Tierra Del Este Unit Eighty Nine

City of El Paso — City Plan Commission — 4/4/19

SUSU19-00016 — Major Preliminary

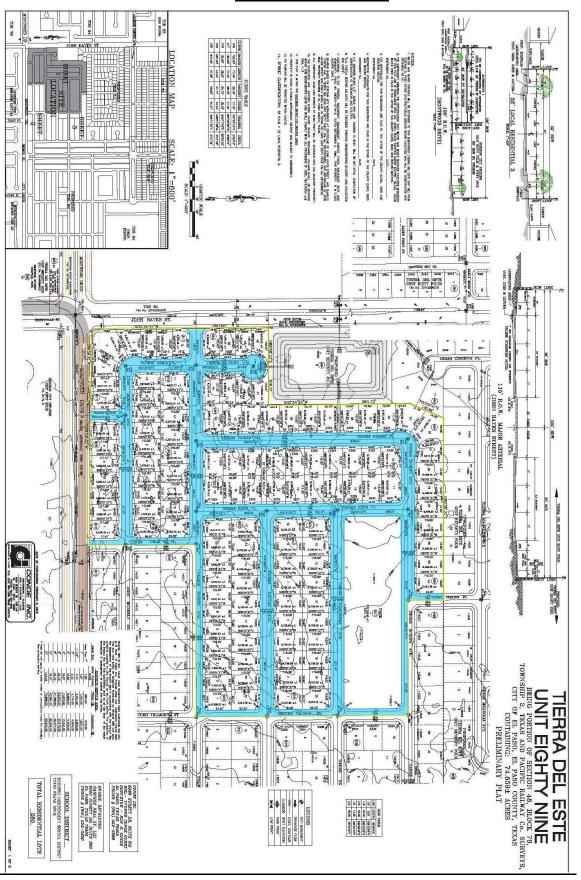
- 1. Update street cross section for John Hayes Street with hike and bike detail to include headers curbs as per DSC Section 6-19.
- 2. Tierra Del Este Unit 74 drainage infrastructure must be constructed and accepted prior to or concurrently to this proposed subdivision.
- 3. Verify proposed curb type for alley cross sections in comparison to previous approved designs.
- 4. At the improvement plan stage, protect the subject property from storm water runoff from the adjacent terrain.
- 5. The subdivision shall be tied to a horizontal control by bearing and distance to either a section corner, survey line, the National Geodetic Survey monument, City monument, or other know and accepted survey points. This tie shall be delineated on the plat sheets.
- 6. Some of the proposed storm-water runoff arrows were not shown in some areas of the subdivision on the preliminary plat sheets.

- 1. Show proposed drainage flow patterns on all sheets of the preliminary plat.
- 2. All downstream storm-water management facilities should be in place prior or concurrent to development of the subject subdivision, i.e. Tierra del Este Unit 74 & 83.
- 3. Show existing surrounding drainage flow pattern arrows 200' feet outside subdivision perimeter on the preliminary plat.
- 4. At the improvement plan stage, protect the subject property from storm-water runoff from the adjacent terrain. Define how

- 5. The subdivision shall be tied by bearing and distance to either a section corner, a survey line, a grant line, or other known and accepted survey points this tie shall be delineated on the plat.
- 6. Provide a more visible scale for typical street cross sections.
